**SuperB Linac
VME Beam Position Monitor**

Andrew Young and Steve Smith

17 June 2013

Charge

Measuring Two Bunches

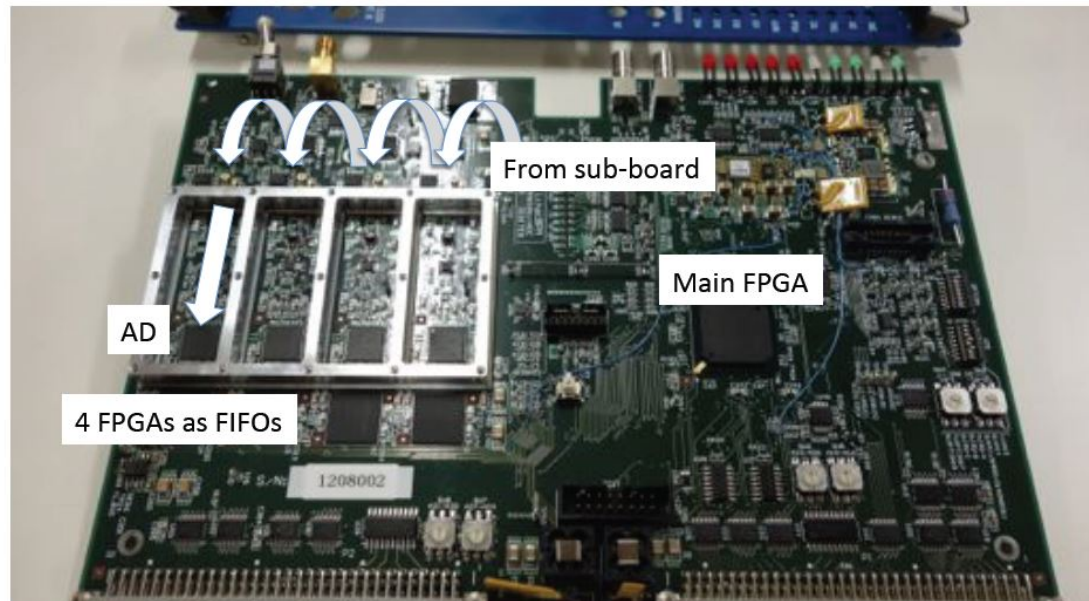
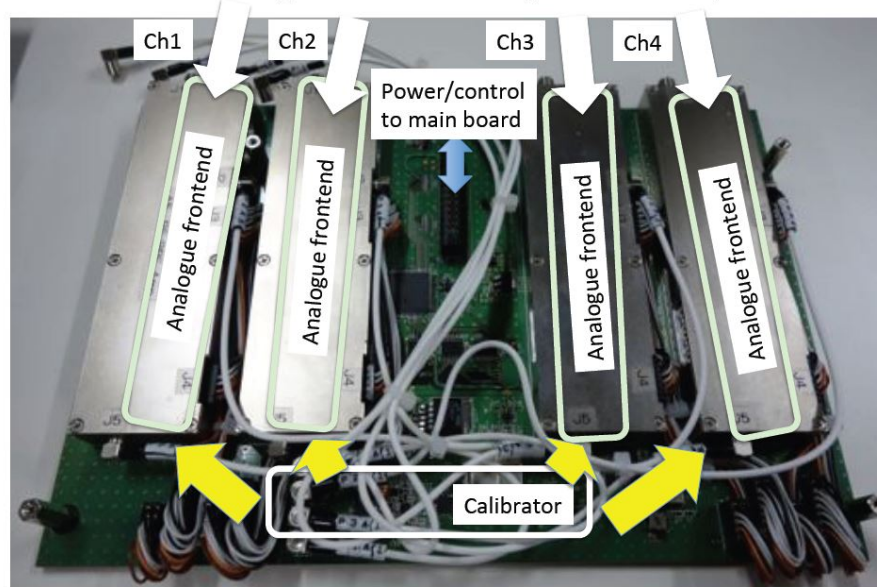
- Two-bunch performance is important for identifying and correcting wakefield kicks
- Measurement of two bunches not yet demonstrated
- Recommendations:
 - Beam test
 - Create artificial 2nd bunch with splitter, delay, combiner
 - Expect to measure same position of two bunches
 - Offline synthetic 2nd bunch
 - Record waveforms from single bunch beam
 - Add signal from opposite strip, delayed by 96 ns
 - Expect 2nd bunch position opposite of 1st.
- Test with 2 bunch beam as soon as possible

KEK Noise problem

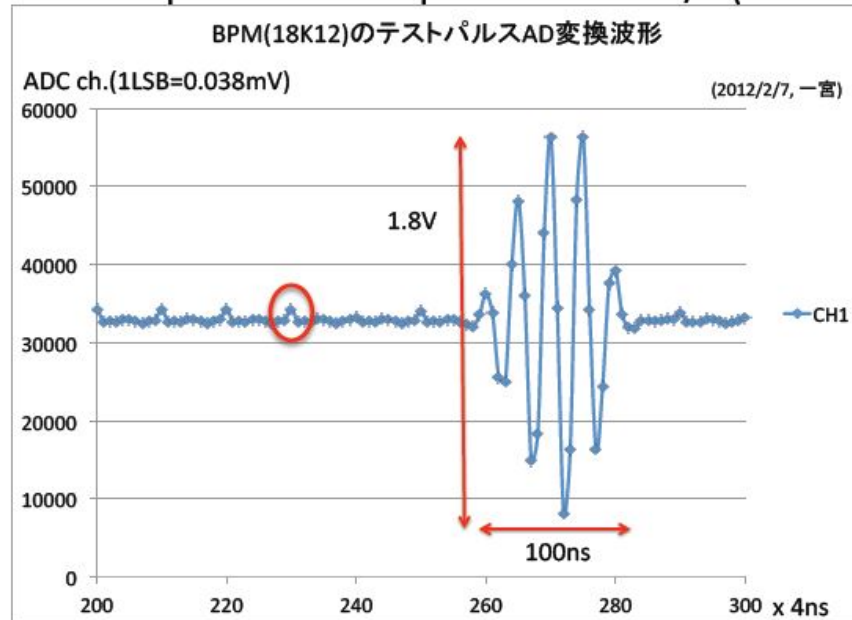
- 300MHz tone pulse are sampled at 250MS/s (under-sampling method).

- Almost same height and single AD clock cycle pulses (noise) are observed.
 - On an adjacent channels, same phenomenon is observed too.
 - Bit pattern:
 - Normal data: 1000_0000_0000_XXXX
 - Noise data: 1000_0101_0101_XXXX
- Such a kind of noises may happen at FIFO input and/or ADC inside. (decimation?)

KEK Schematic modifications

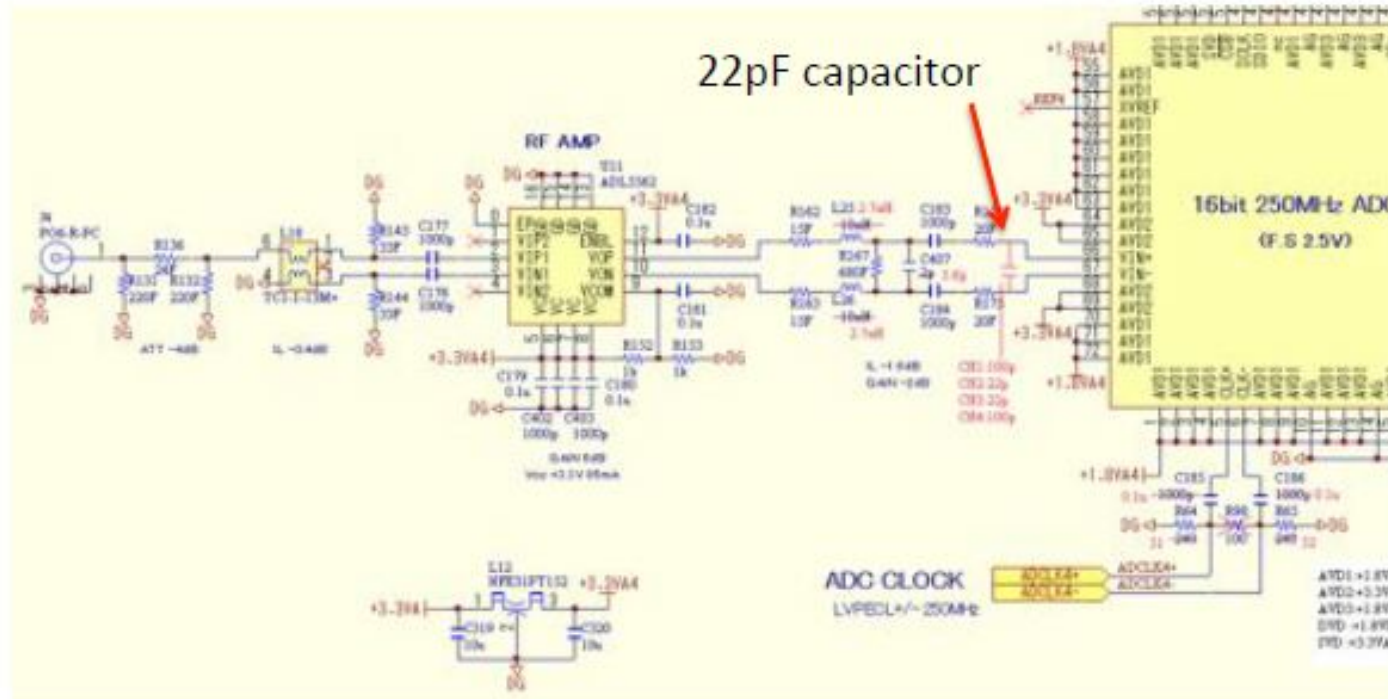
- Finally we find two remedies to remove this noise.
 1. Insert 22pF capacitor between differential signal line at ADC input.
 - Act as LPF and normal-mode noise stabilizer.
 2. Tune Data/Clock timing at FIFO by 0.2ns (tentative).
- Both remedies are mandatory to fix this problem. So, we guess both causes contribute. (inside ADC malfunction, metastable at FIFO input)

Response of KEK filter

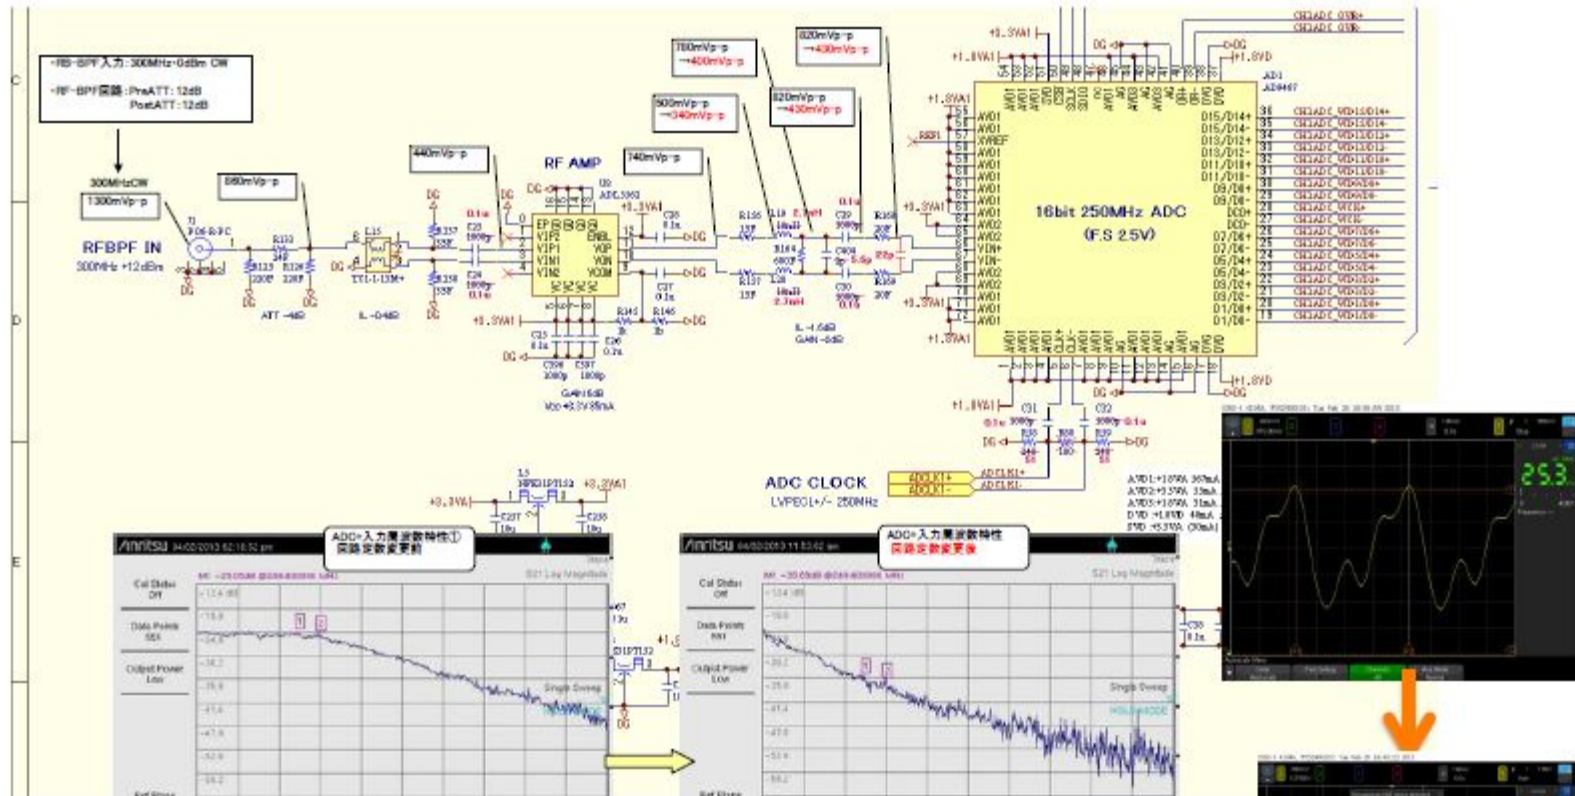
The 22pF limited the BW to the ADC, this is why Steve Smith suggested going to a lower frequency front end.

SLAC Schematic Quick Modifications

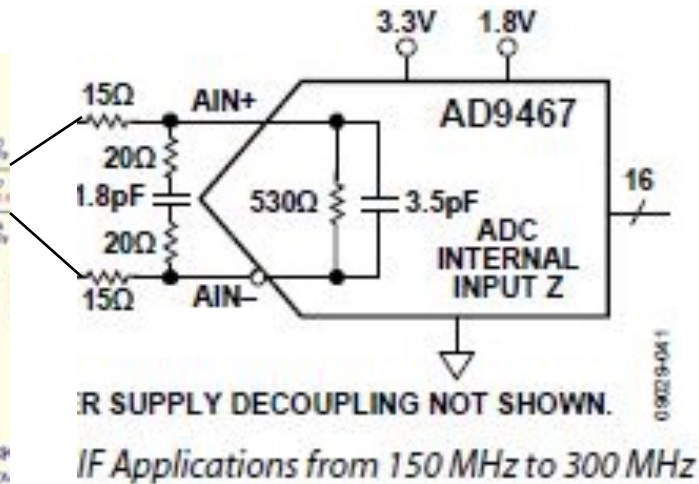
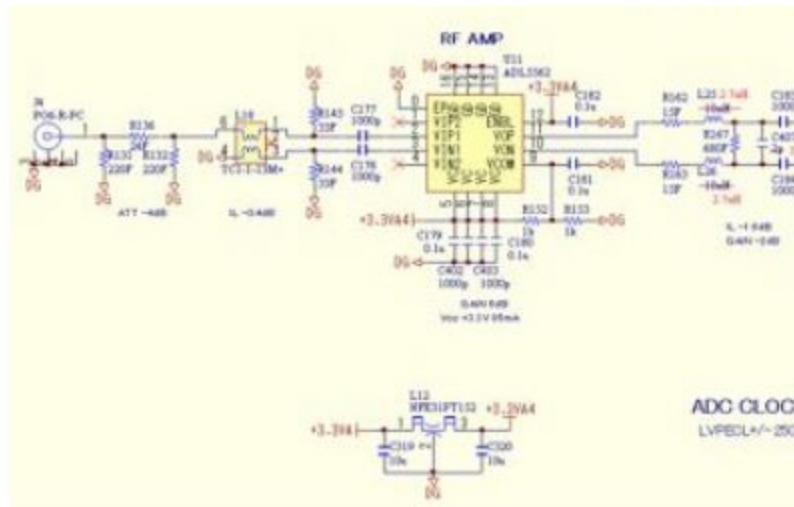
Using 1mm by 0.5mm resistors I modified The VME board to place the 20ohm resistors and the 1.8pF cap in a place where there were only two pads for the 15 ohm resistor (i.e., creating a resistor totem pole).

Time-Domain Response

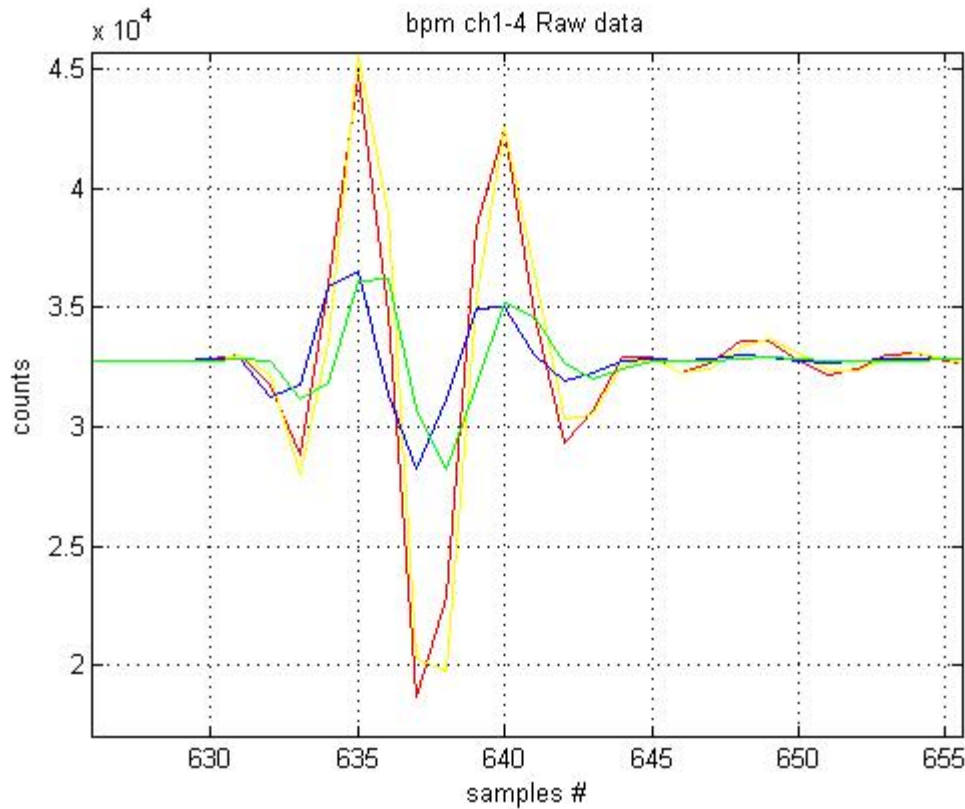
A factor of ~ 10 dB improvement in SNR.
Did not improve the resolution, why??
Did not have enough time to figure out why there was no improvement.
Would like understand why that happen.

Figure 52. Differential Transformer-Coupled Configuration for IF Applications from 150 MHz to 300 MHz

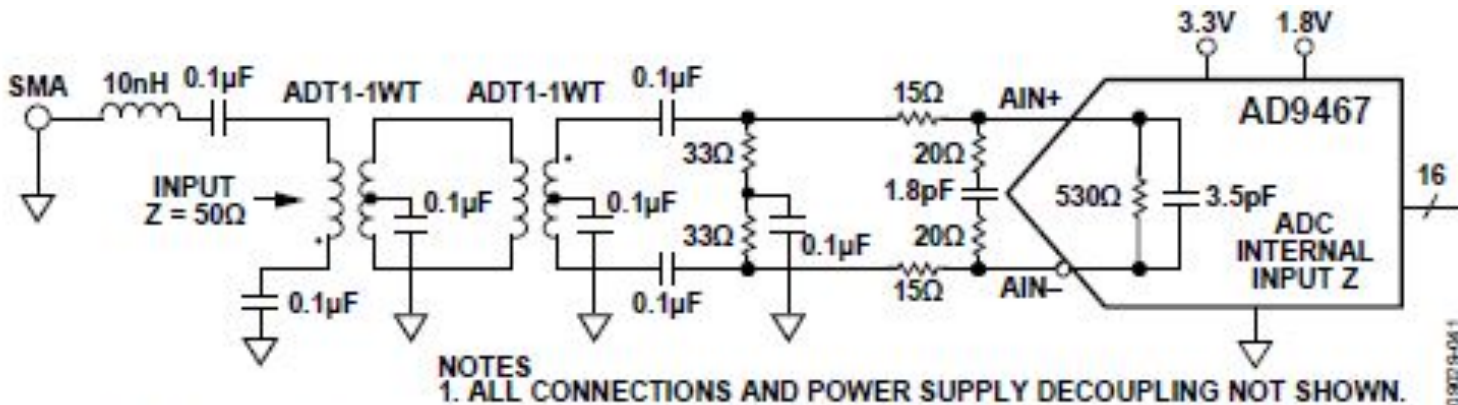
SLAC Circuit uses Coilcraft transformers and RF front end electronics. SLAC has designed anti-aliasing filter at the input of ADC.
